## MEMO

**From:** Lynn Schmidt, PE, CFM, Statewide Flood Engineer, Ecology SEA Program

**Date:** April 23, 2018

**Subject:** Stream Channel Migration and the Clallam County SMP Update – Release of final documents and response to County questions

**Example 8: Lyre River – Near the mouth - Map 46 of the Puget Sound Streams (WRIAs 18 – 19) report.**

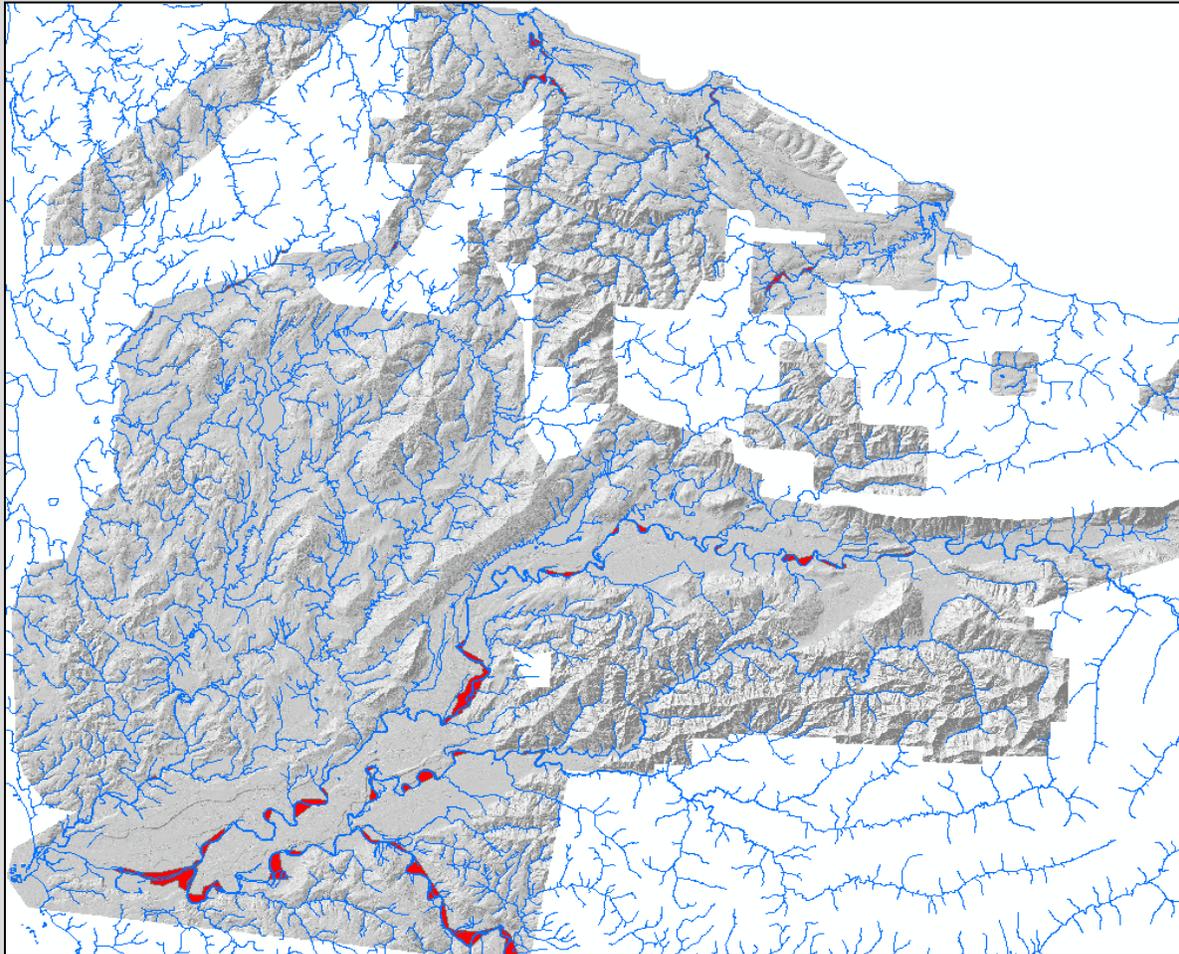
The CMZ area near the mouth of the Lyre River is characterized by state and conservation lands on the east-side and rural residential lands on the west-side. On the west side of the river, most of the rural residential lots between the river and W. Lyre River Road (north of intersection with Harrison Beach Rd) are fully or substantially within the mapped CMZ. Landowners in this lower river reach have questioned the width of the CMZ. The homes are setback generally more than 100 feet from the river and based on LIDAR on terraces 10+ feet above the river. There is no evidence of any significant channel movement on aerial photos in at least the last 20+ years. What is the basis of the outer extent of the CMZ on the west side of the river in the developed areas near the mouth? How much of this is based on the erosion hazard buffer calculation?

Ecology Response: In the Pacific Streams (WRIA 20) report, Chapter 4.4. (4) describes delineation of areas of potential channel migration, including Underfit Streams (page 33), and Figure 4.7 and related text (pages 34-35) addresses the issue of stream valleys formed by glacial processes such as scouring and outwash.

In addition, the Lyre River is specifically explained in Chapter 4.4 (7) on page 38-39:

"The Lyre River example of valley expansion (Figure 4.6) was observed in many streams evaluated by this study. Many included obvious examples of shallow or deep-seated landslides, both recent and prehistoric that had occurred along stream valleys. The potential channel migration boundary in reaches where evidence of valley widening is occurring includes the entire valley bottom plus a portion of the valley wall. The streamlined pCMZ delineations were not intended to be precise, but rather meant simply to call out areas where a more detailed assessment, including a geotechnical analysis, is needed to determine the geographic extent of the hazard. The area where a geotechnical setback buffer is needed is indicated on the maps with black dots in the CMZ boundary line."
